RFP # 2-2024 - Category 2 Internal Network Connections Questions & Answers

EXISTING FLOOR PLAN

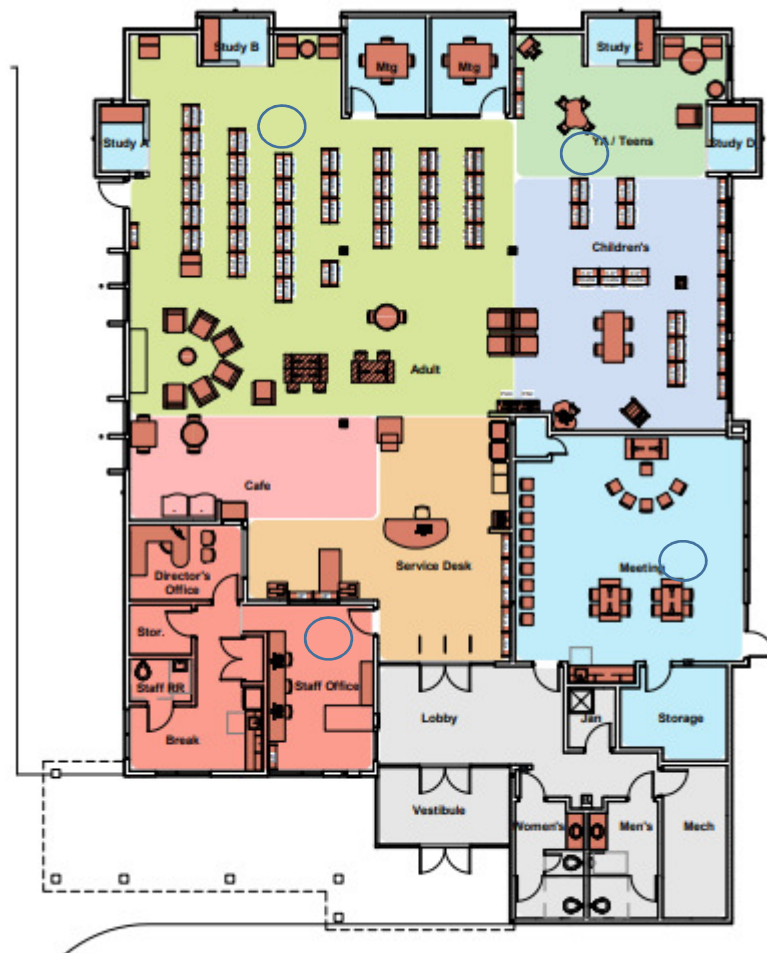
- Please provide a map of where the 5 access points are going to be installed.

- The below is the layout location of Giodone and respective locations are defined with:

Library at the Y does not have a diagram but has one Wap less than 300ft away from the IDF that will need both the Cat 6 run and the new WAP as replacement.
